TOWN OF
BRECKENRIDGE

Planning Commission Meeting Agenda

Planning Commission Staff Report

Subject: 319 North French Street
(Class B Historic, Preliminary Hearing; PL-2018-0367)

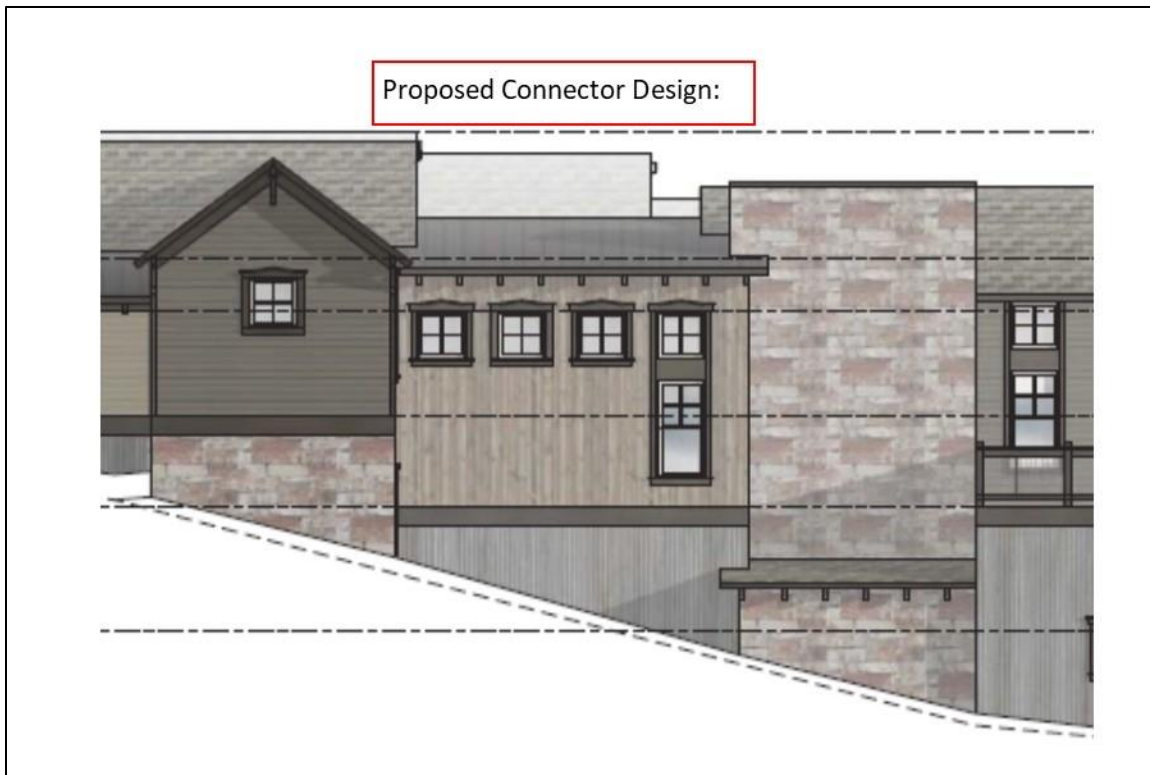
Staff is generally comfortable with the design as it relates to Priority Design Standard 121 but would like feedback from the Commission on how the design relates to Priority Design Standards 36, 80 and 144.

The new addition will be attached by a connector that minimizes removal of historic fabric from the structure and is also setback 4.8' behind and is separated 8.5' from the front façade of the historic structure. To abide with Priority Design Standard 36, staff believes the addition should be setback further and be separated at least half of the width of the front façade (11.5") from the historic structure. This would allow the original proportions and character of the historic structure to remain prominent and not have the primary structure obscured. Staff further believes the addition should be set back so that it does not appear there are two primary structures onsite.

Priority Design Standard 50 states: *“Projects that incorporate no more than 50 feet of lot frontage are preferred and the front façade of a building may not exceed 30 feet in width”*. The project uses 49' of lot frontage and does not exceed 50' but since the addition is not set back at least 5' behind the front façade of the historic home, the width of both structures count toward the total of the front façade and thereby exceed the recommended 30'. Based on staff's interpretation the design does not comply with Priority Policies 36 and 144. Does the Commission concur?

The development's module size is within the range of surviving historic buildings in the area, but the addition is large in scale when viewed from the alleyway relative to other confirming structures in the character area. Does the Planning Commission feel this proposal meets Priority Policy 80?

319 NORTH FRENCH STREET
 LOT 25, SNIDER ADDITION TO THE TOWN OF BRECKENRIDGE
 TOWN OF BRECKENRIDGE, SUMMIT COUNTY, COLORADO
 TITLE
 SITE PLAN

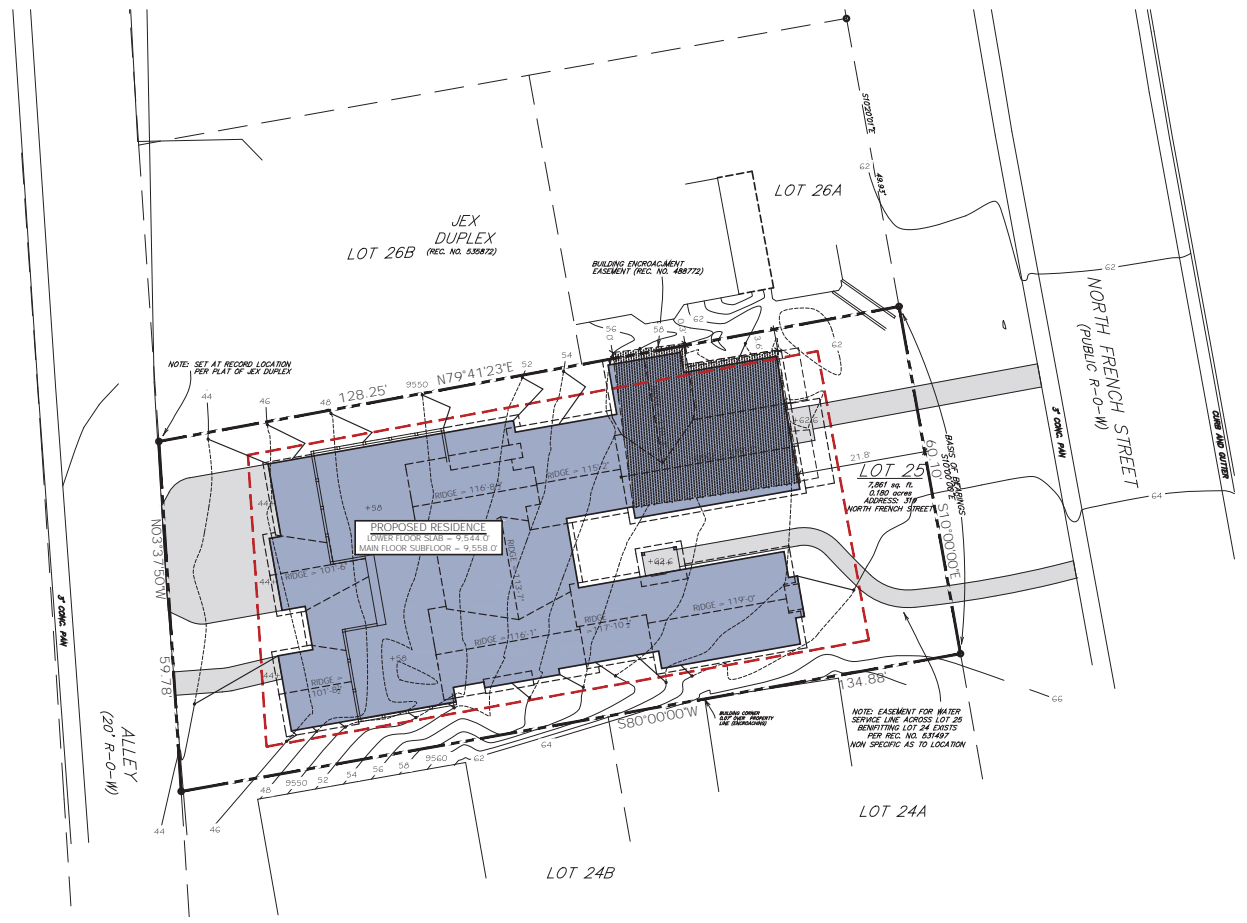
Site Plan: The project matches the Town grid (Priority Design Standard 5) and that the new construction reinforces the unity of the block (Priority Design Standard 8). All parking is located at the rear of the lot accessed from the Ridge Street Alley (discussion below).

The drawings show the building exceeds the front yard setback at 25', with an additional 21' to the roadway. Side yard setbacks are met at 6' on the north and 5' on the south. The rear setback is being met with 16' proposed. As noted previously, the historic home encroaches 1' onto the Jex Duplex property and is permitted via a building encroachment easement. Staff has no concerns.

1
A2.2 MAIN LEVEL FLOOR PLAN
 SCALE: 1/8"=1'-0"

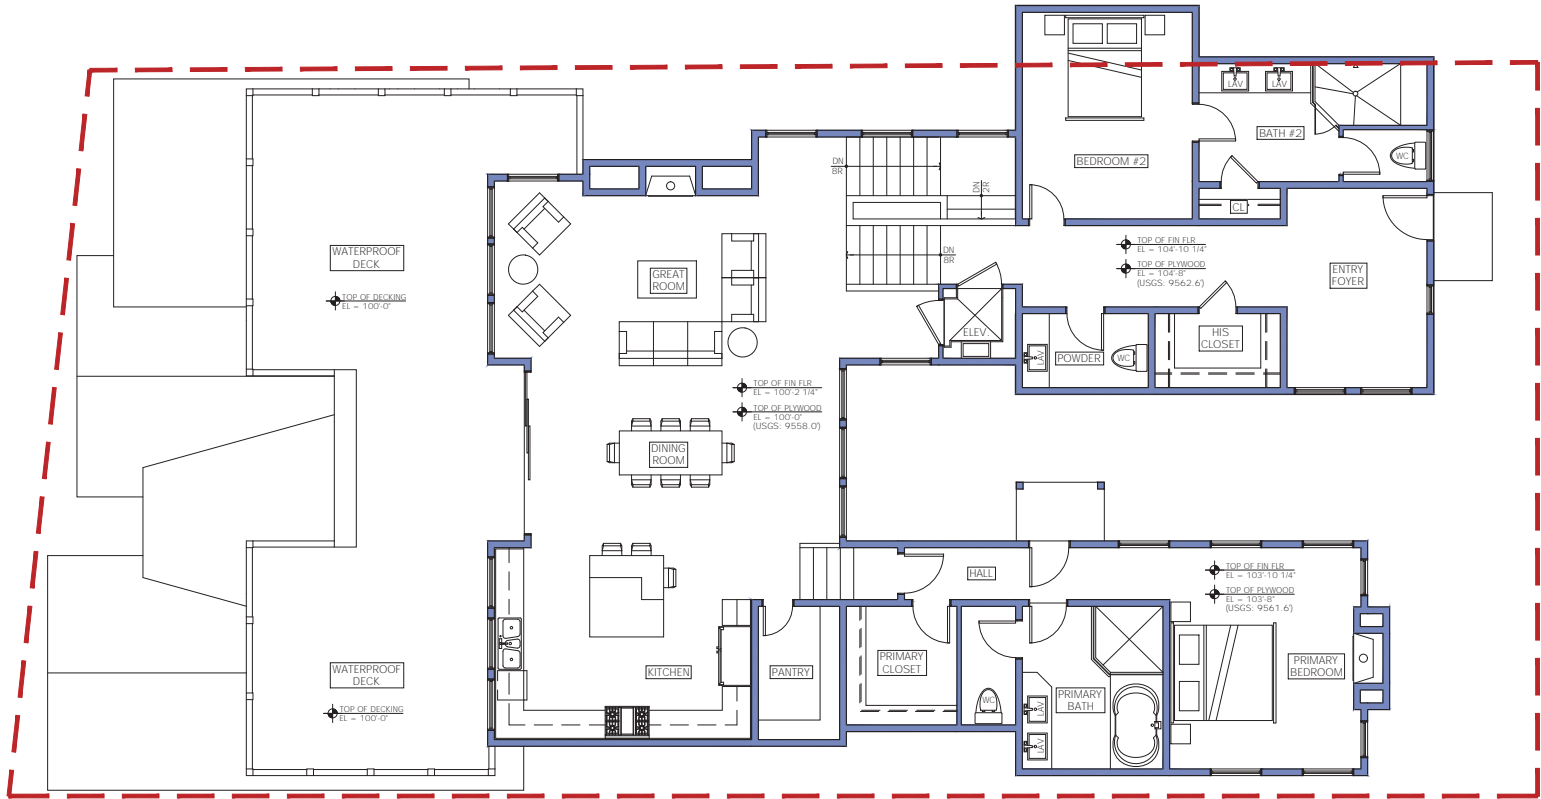
- Priority Design Standard 37: Fail – The proposed addition's height needs to be reduced to be compatible with the character area.
- Priority Design Standard 80: Fail – The southeastern portion of the connector obscures the original proportions and character of the historic structure.
- Priority Design Standard 80A: Fail – The design of the connector needs to be longer based on the length of the historic home. The connector is not 2' lower than the historic home's adjacent ridgeline. The connector is not setback 2' from the corner of the addition module. Add to this from above connector comments
- Priority Design Standard 82: Fail – The back side of the addition appears large as viewed from the alley.
